W-1 LEON CREEK: HWY 151 TO HWY 90 - UPPER SEGMENT
Solicitation Number: CO-00351
Job No.: 19-4528

ADDENDUM 2
September 24, 2020

Sheet **C-1**
24 of 67

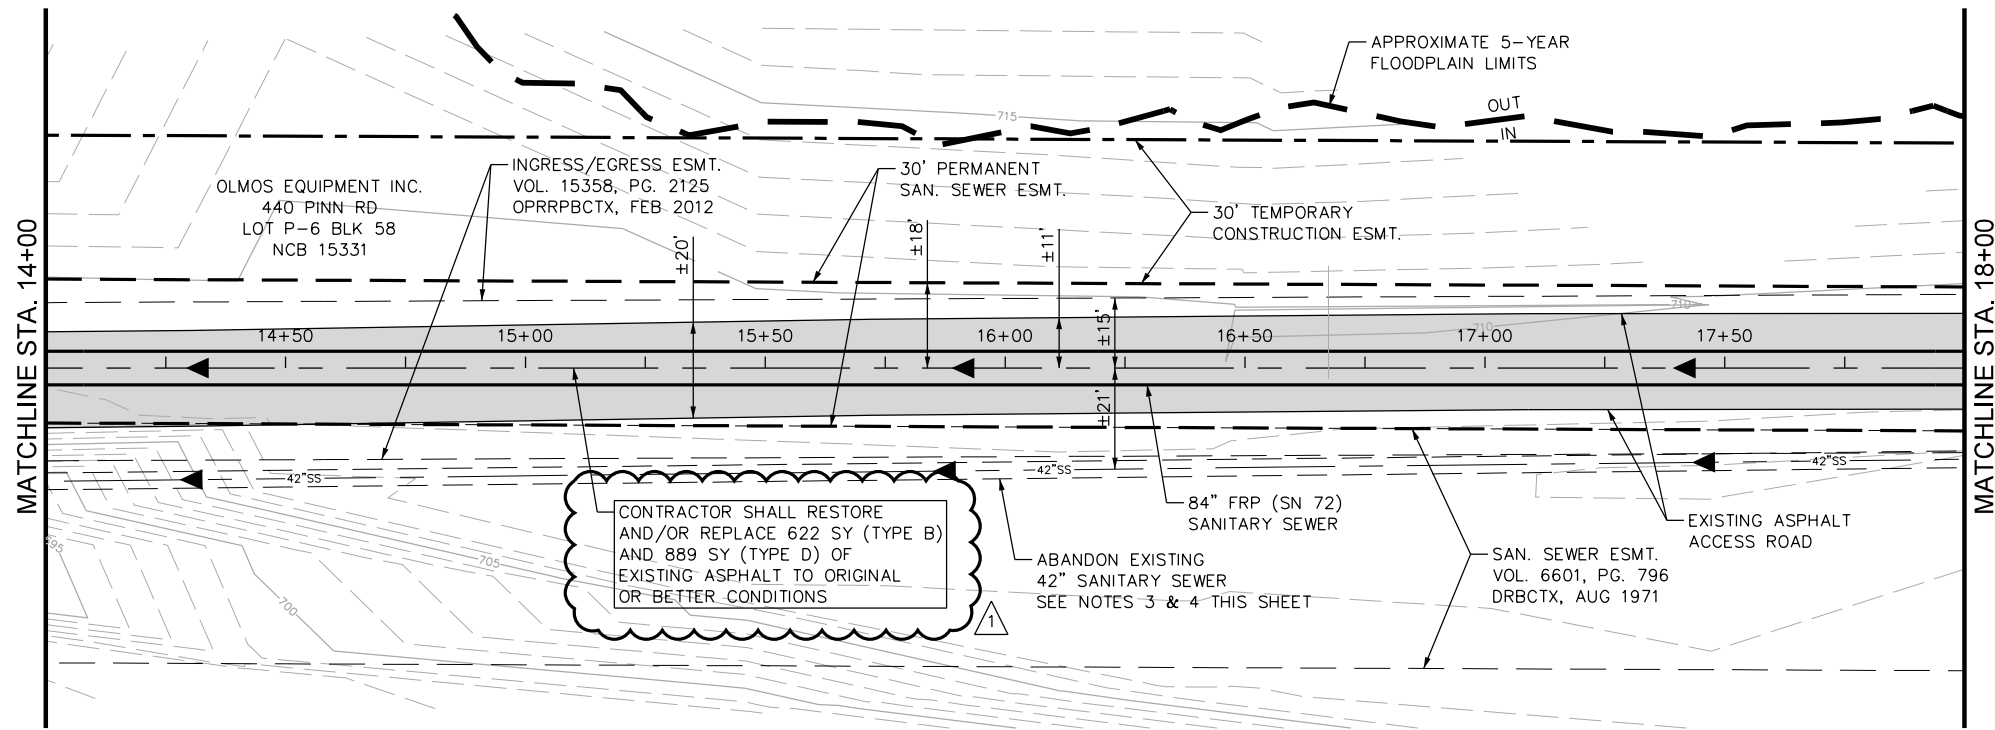
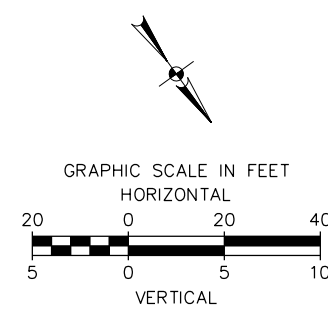
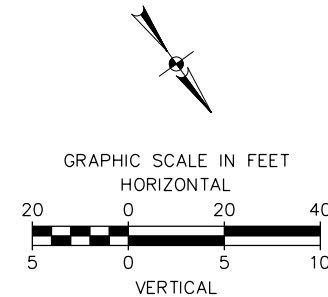
- Sheet C-1: Line “A” Plan and Profile Sheet STA 9+94.15 to 14+00 – Replace sheet in its entirety.
 - Revised Quantity for Line Item 205.2 Hotmix Asphalt Pavement Type B -10 Inches Pavement Thickness

- Revised Quantity for Line Item 205.4 Hotmix Asphalt Pavement Type D – 2 Inches Pavement Thickness
 - Revised Quantity for Line Item 208.1 Salvaging, Hauling, & Stockpiling Reclaimable Asphalt Pavement (2 Inches Depth)

- Revised note to indicate, “Contractor shall Restore and/or Replace 653 SY (Type B)”
- Sheet C-2: Line “A” Plan and Profile Sheet STA 14+00 to 18+00 – Replace sheet in its entirety.

Sheet C-2
25 of 67

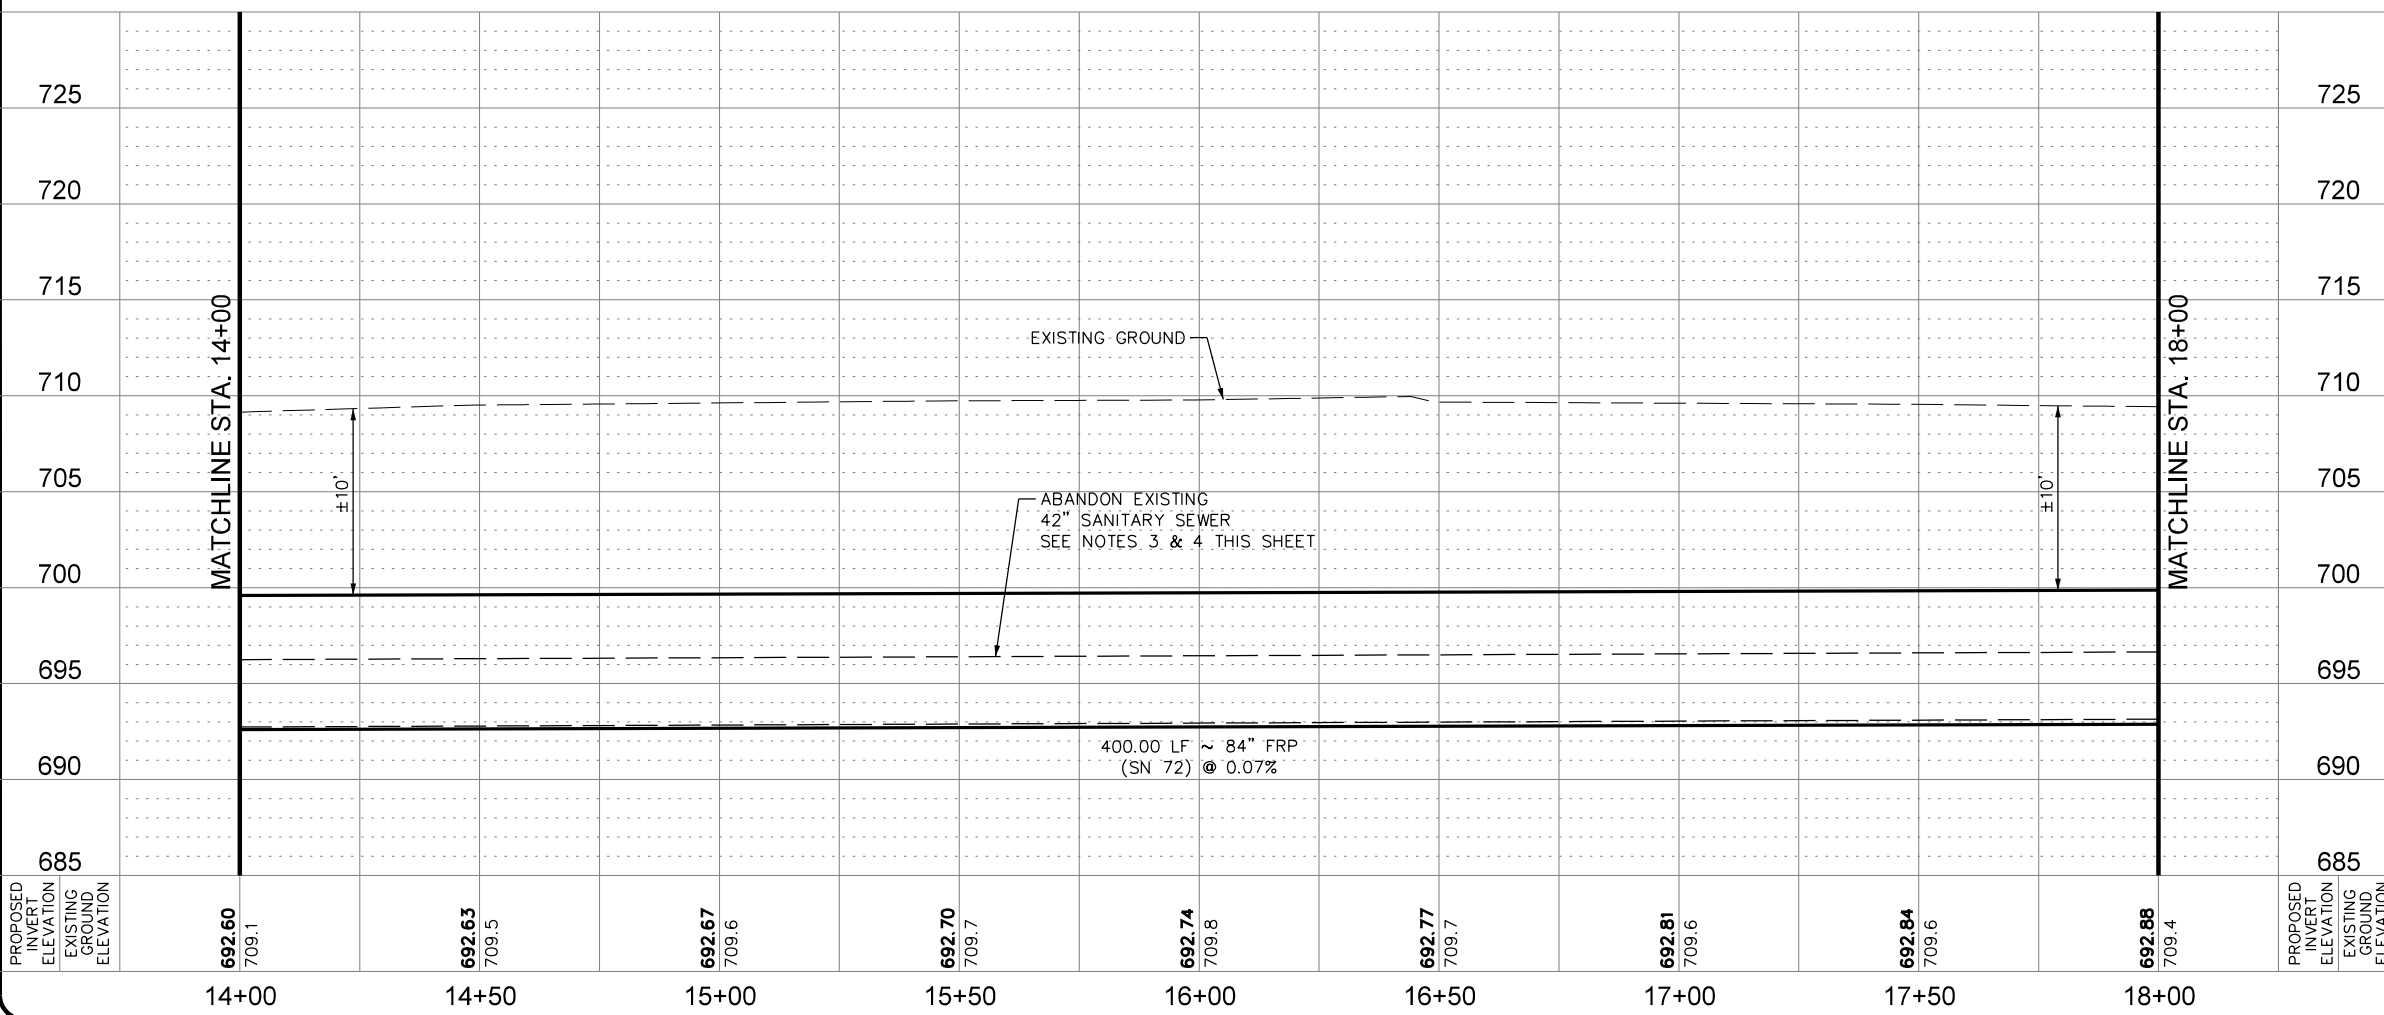
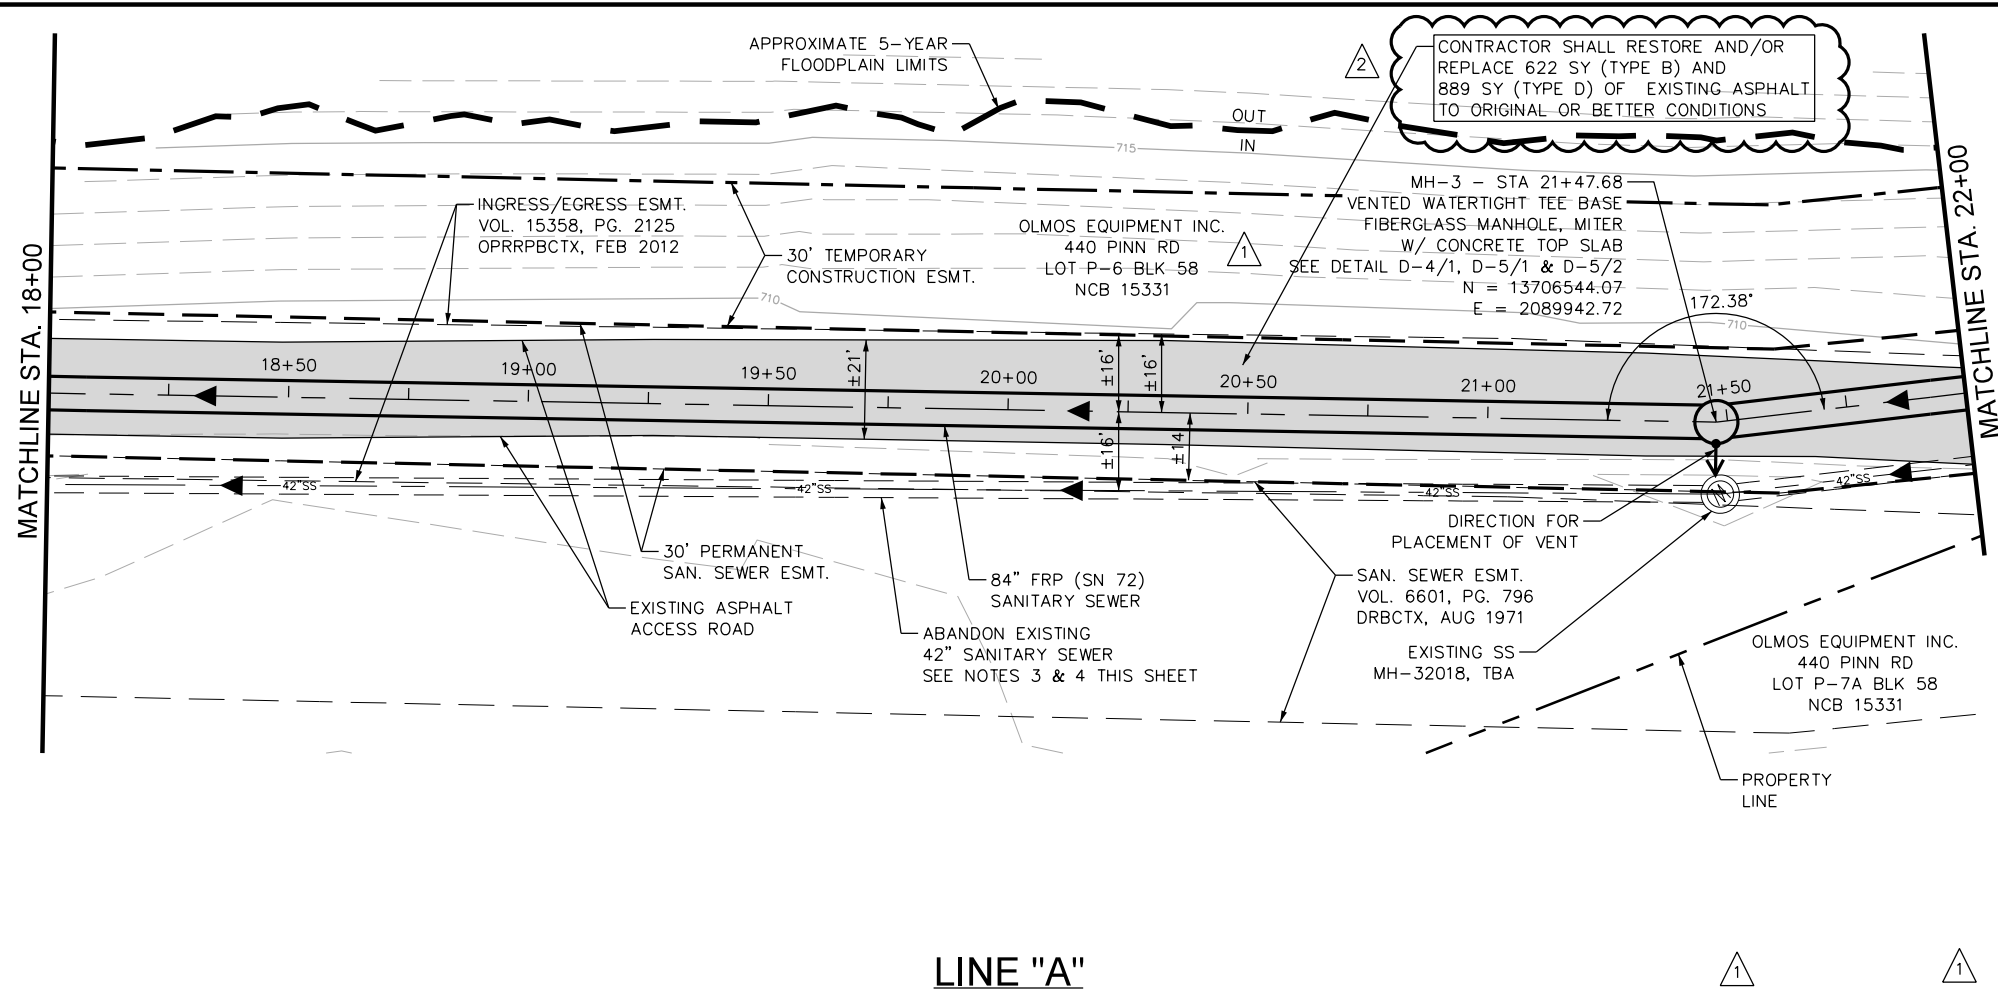
- Revised Quantity for Line Item 205.2 Hotmix Asphalt Pavement Type B -10 Inches Pavement Thickness and Note
- Sheet C-3: Line “A” Plan and Profile Sheet STA 18+00 to 22+00 – Replace sheet in its entirety.

SAWS JOB NO. 19-4528
W-1 LEON CREEK: HWY 151 TO HWY 90
UPPER SEGMENT
LINE "A" PLAN AND PROFILE
STA 18+00 TO STA 22+00

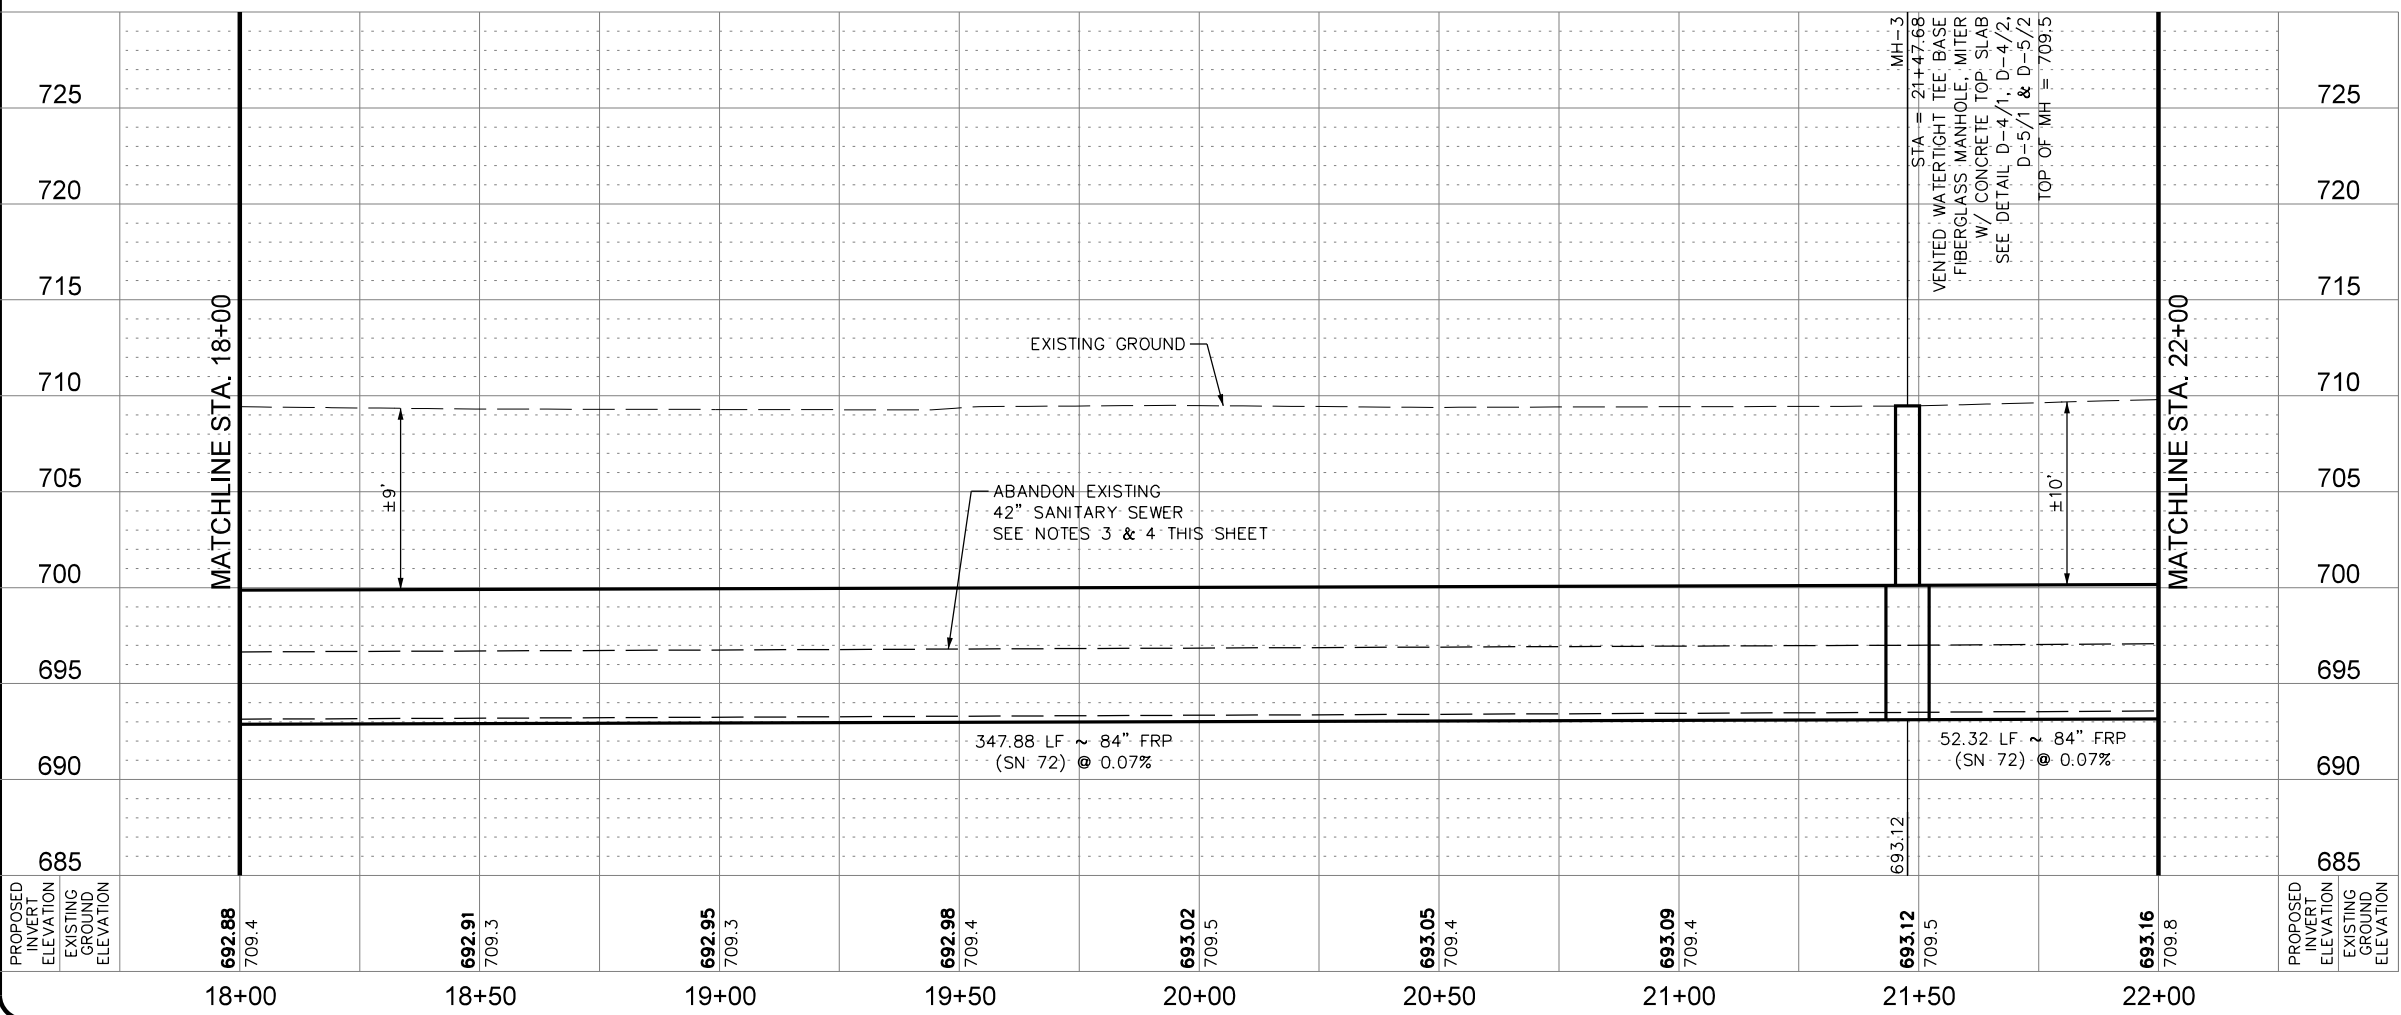
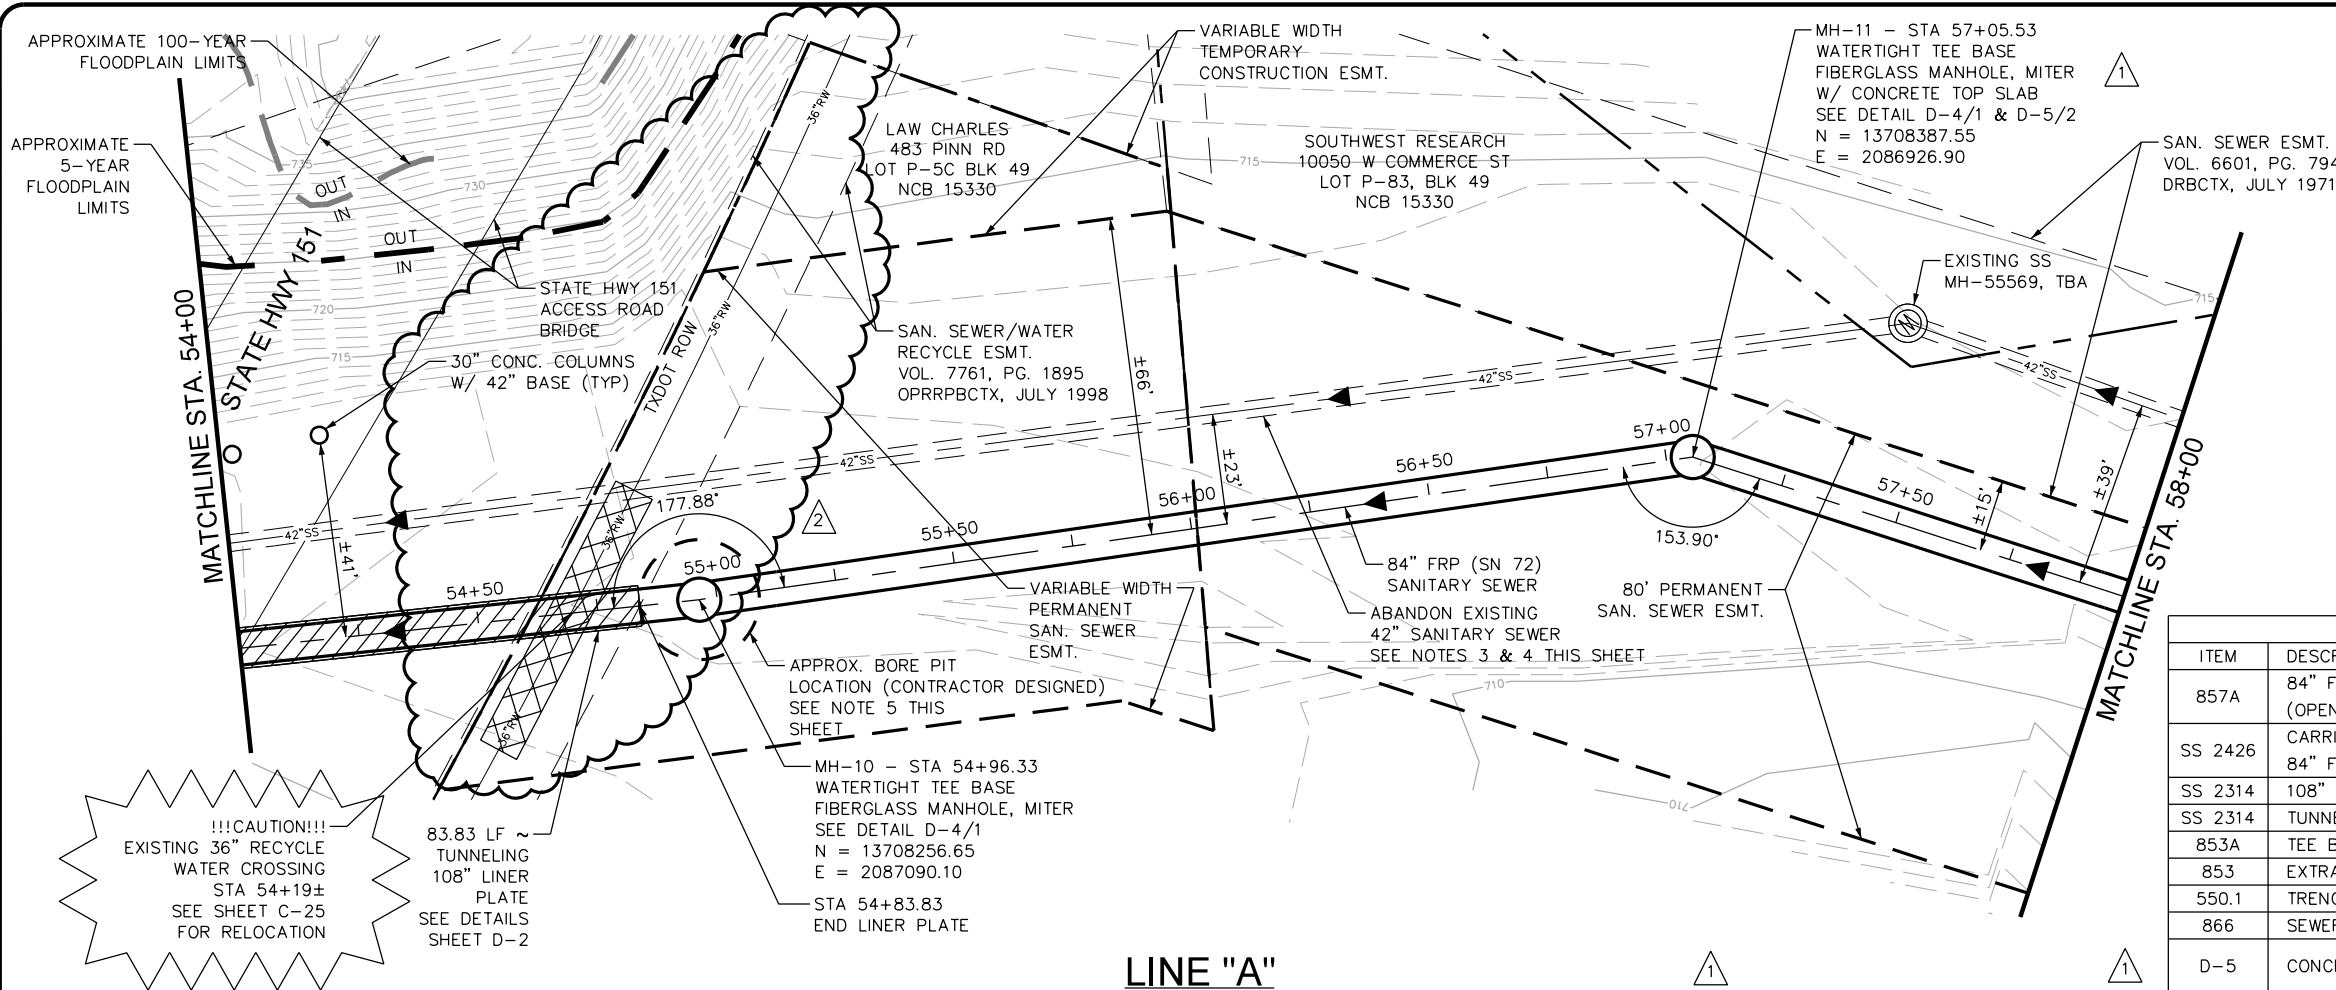
- Revised Quantity for Line Item 205.2 Hotmix Asphalt Pavement Type B -10 Inches Pavement Thickness and Note
- Sheet C-12: Line “A” Plan and Profile Sheet STA 54+00 to 58+00 – Replace sheet in its entirety.
